Hertsfield Barn, Marden, Kent, TN12 9BW

STATEMENT OF

Prepared For: Planning appeal, for retrospective planning permission at Monk Lakes, Staplehurst Road, Marden, TN12 9BS. Application reference 11/1948. Appeal Reference - APP/U2235/W/20/3259300

Subject Matter: The potential for groundwater flooding resulting from the unauthorised development at the neighbouring property known as Monk Lakes.

Figure 2, Schematic surface water attenuation scheme #
 (after 2675/MBCR2/A7, Vol2 part F of the ES, section 4.1 of Hafren 2019, pdf page 325 of the ES).

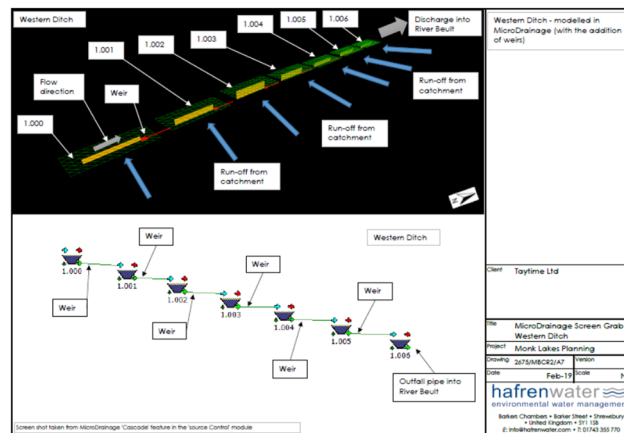
2.1.1 Section 1.11 indicates an Updated Proposed Landscaping Plan (ref. P20-0831_02) has been submitted and states *'The proposed landscaping along the western and southern appeal site boundary remains the same'*. The proposed surface water attenuation strategy presented as part of the Environmental Statement (Next Phase, February 2019, CD1.1) has not been included within the design which suggests the Appellant has not considered how it will be incorporated within the landscaping of the development, given the limited space along the western margin and the need to avoid locating attenuation basins within the flood plain. The only drawing that I am aware of is the generic screen grab from the run-off model presented below.

- 4.3.5 As mentioned previously the proposed attenuation basins for the surface water run-off are not shown on the proposed development plans, and so it is not clear that there is sufficient space to accommodate them within the proposed landscaping.

Figure 3 Environment Agency Risk of flooding from Rivers and Sea (ROFRAS)

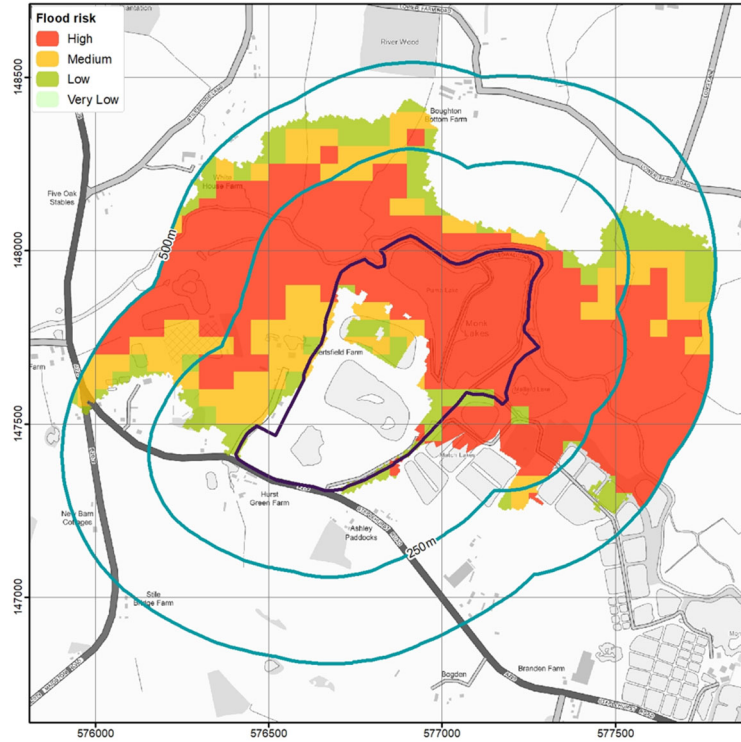
Fluvial flooding is acknowledged as a risk, and will require the implementation of a flood storage compensation scheme to mitigate the impact on other receptors. I note that parts of the site currently designated at Low risk in Flood Zone 1, are likely to have been at a lower elevation (and therefore at higher risk) under baseline (pre-development) conditions. It is evident from the data in Figure 3, the Environment Agency model used to define the flood zones is using the recent topography after land raising has occurred.

Figure 6 Environment Agency Surface Water flood depths for the 1 in 1000 year event.

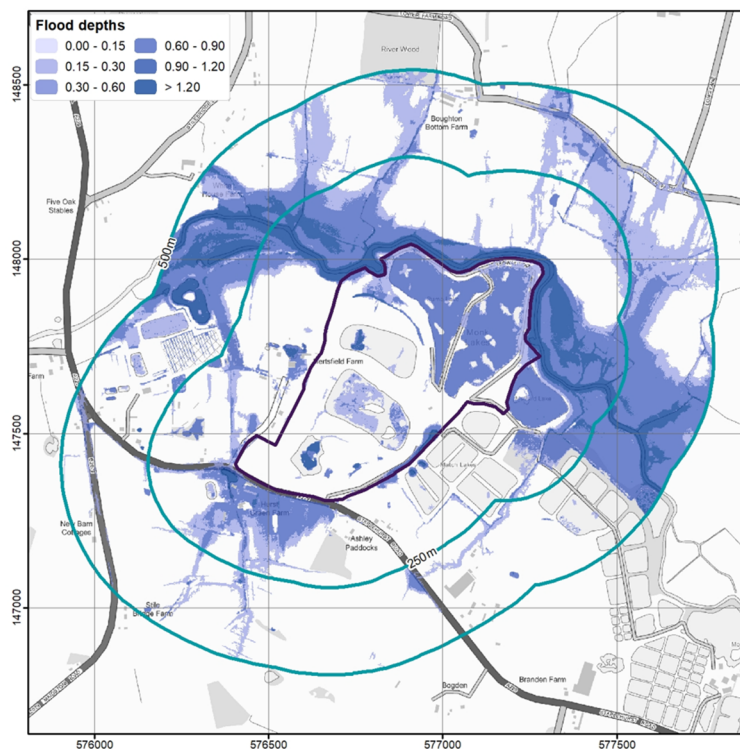
Information on the pluvial (surface water) flood depth is presented showing the extreme (1 in 1000, 0.1% AEP) and medium risk (1 in 100, 1% AEP) scenarios. The extreme case has a low probability of occurring, but highlights the risk areas around Hertsfield Barn and the A229 to the south. The risk of surface water flooding is likely to be increased along the western margin of the development due to the presence of a steep slope and the low permeability of the material used to create the raised lake. The cumulative impact of the development on the existing off-site, surface water flood risk should therefore be considered within the impact assessment.

Figure 8 Environment Agency Maximum extent of flooding from reservoirs.

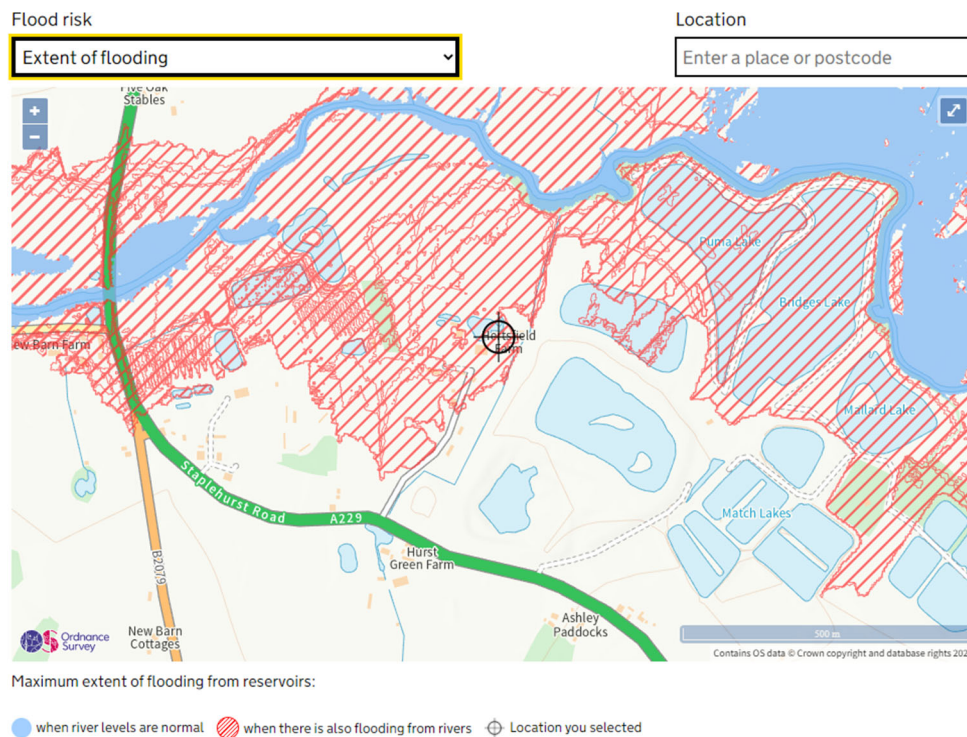
As indicated in Figure 8, Hertsfield Barn lies within the extent of reservoir flooding when there is also flooding from rivers. There will be additional cumulative risk from the adjacent raised reservoir which should be included within the impact assessment. There will remain a residual risk for as long as the raised fishing lakes are in operation, and the degree of risk will depend on the ongoing inspection and maintenance of the lake banks. To provide context, Figure 1 is a photograph taken from a drone showing the close proximity of Hertsfield Barn to the raised lakes.

Figure 1 Estimated groundwater contours (from ESI,2015, Figure 8)

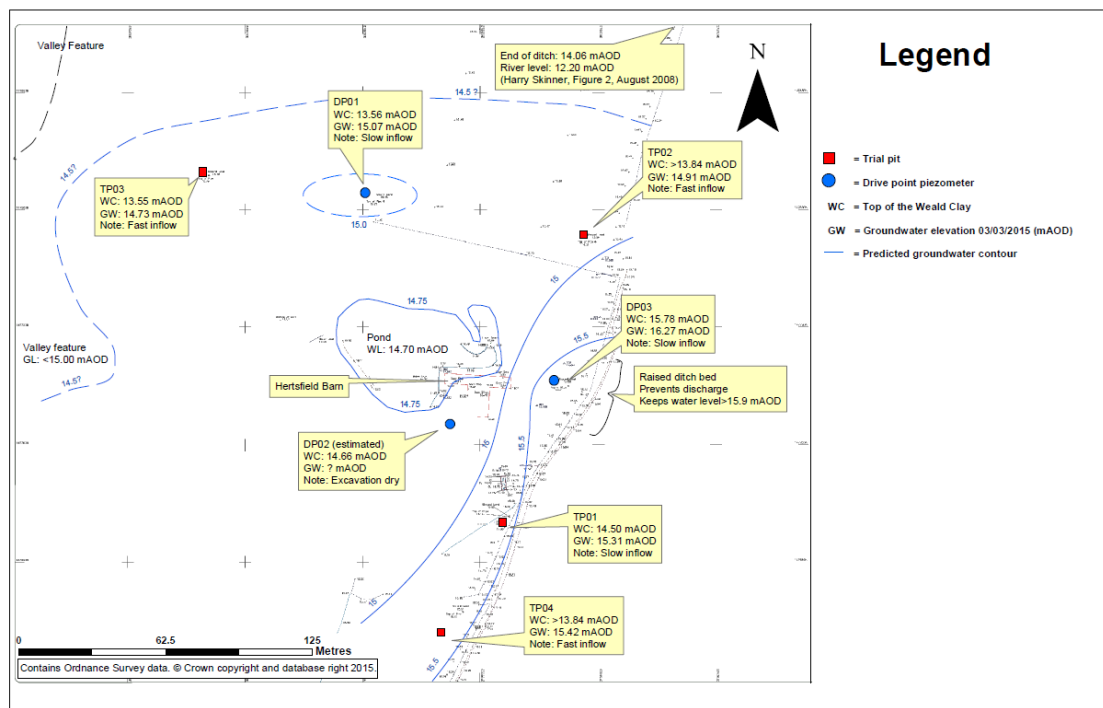
'By setting the pond water level approximately 1.3m higher than a measured value the hydraulic gradient from the made ground west towards the pond is not revealed'.

The amended cross section is presented as Drawing 2675/MBCR2/03 (page 244 of the ES pdf). It confirms groundwater flow direction is likely to be towards Hertsfield Barn which is consistent with other shallow groundwater data (ESI, 2015). Unfortunately, the additional ESI data, which is provided below in Figure 1, is not shown on the amended cross section. Amended groundwater contours are presented in Drawing 2675/MBCR2/03 in Hafren Water 2019 (page 248 of the ES pdf) which confirm that flow is likely to be towards Hertsfield Barn. The contours do not include any estimates of groundwater levels outside of the Monk Lakes site, i.e. at Hertsfield Barn.

Groundwater contours should include the groundwater low around Hertsfield pond and make reference to the earlier trial pit and groundwater data presented in ESI 2015. As Taytime have not collected any data outside the Western Boundary then the information provided within the ESI report should be considered. If this information is disregarded, then the applicant should state the reasons for this and provide an alternative explanation for the high groundwater and flooding observed.

Figure 4 LiDAR data showing elevation in mm. Left 2002, Right 2008.

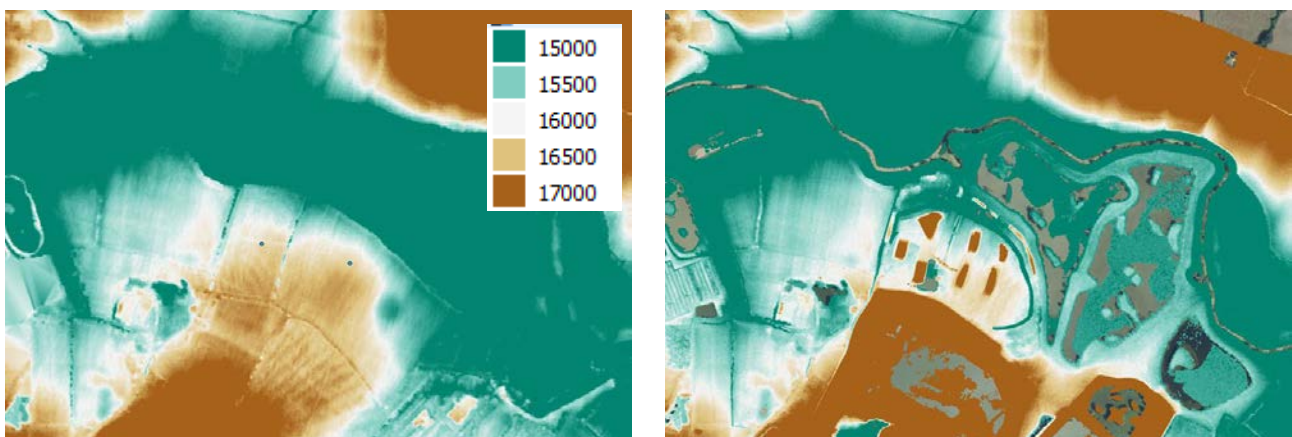
Hafrens findings (October 2019) indicate that the impact on flood plain storage is less than previously calculated, however, this has been done on the basis of a volumetric calculation using a flood level derived from previous work and topographic LIDAR data available from 2002. LIDAR data is also available from 2008 and shows ground levels to be significantly lower than the 2002 levels (Figure 4), presumably as a result of soil removal and other activities.

The flood level used in the storage calculation is 16.3 mAOD, which is understood to be derived from flood modelling undertaken by the Environment Agency (EA), labelled '2011 flood line' in the 2012 FRA. It is not known whether the EA model was developed using the 2002 or 2008 LIDAR. If the 2008 data was used for the flood modelling then it would not be appropriate to compare the 16.3 mAOD model output with the 2002 LIDAR levels, as the flood levels would be lower, because the underlying ground levels from which the flood levels were derived would also be lower.

Figure 1 Estimated groundwater contours (from ESI,2015, Figure 8)

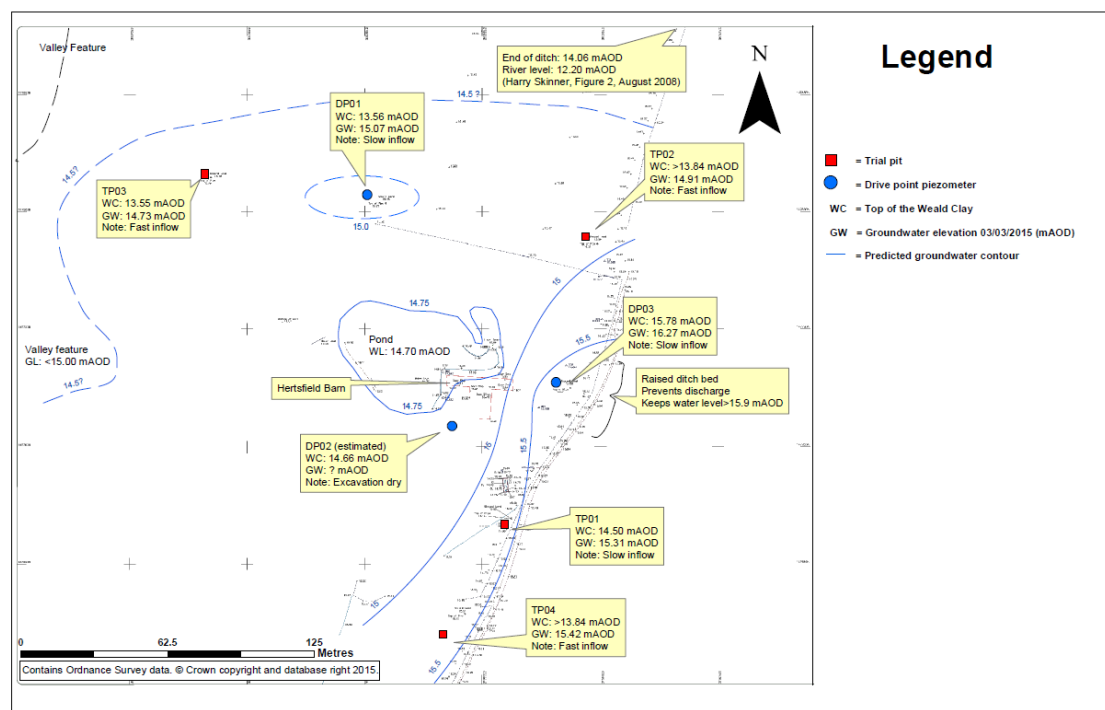
'By setting the pond water level approximately 1.3m higher than a measured value the hydraulic gradient from the made ground west towards the pond is not revealed'.

The amended cross section is presented as Drawing 2675/MBCR2/03 (page 244 of the ES pdf). It confirms groundwater flow direction is likely to be towards Hertsfield Barn which is consistent with other shallow groundwater data (ESI, 2015). Unfortunately, the additional ESI data, which is provided below in Figure 1, is not shown on the amended cross section. Amended groundwater contours are presented in Drawing 2675/MBCR2/03 in Hafren Water 2019 (page 248 of the ES pdf) which confirm that flow is likely to be towards Hertsfield Barn. The contours do not include any estimates of groundwater levels outside of the Monk Lakes site, i.e. at Hertsfield Barn.

Groundwater contours should include the groundwater low around Hertsfield pond and make reference to the earlier trial pit and groundwater data presented in ESI 2015. As Taytime have not collected any data outside the Western Boundary then the information provided within the ESI report should be considered. If this information is disregarded, then the applicant should state the reasons for this and provide an alternative explanation for the high groundwater and flooding observed.
